Product Change Notification

1. ECR #: 25-33852-1
Notification #: 788

3. Series:
• T2M - T2M 2MM SHROUDED TERMINAL STRIP

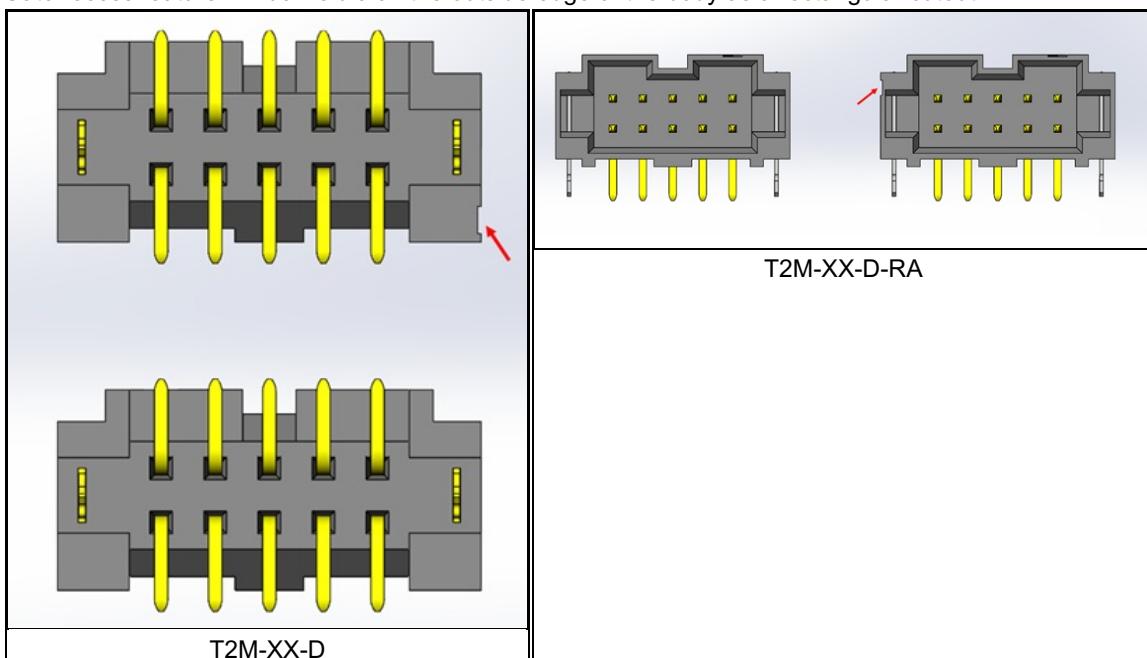
A gate recess feature is possible on the housings for future orders and will be present or not at Samtec's discretion. Variation is possible within an order and from order to order.

Gate recess feature will be visible on the outside edge of the body as a rectangular cutout.

- Form - Added gate recess to body on the outside
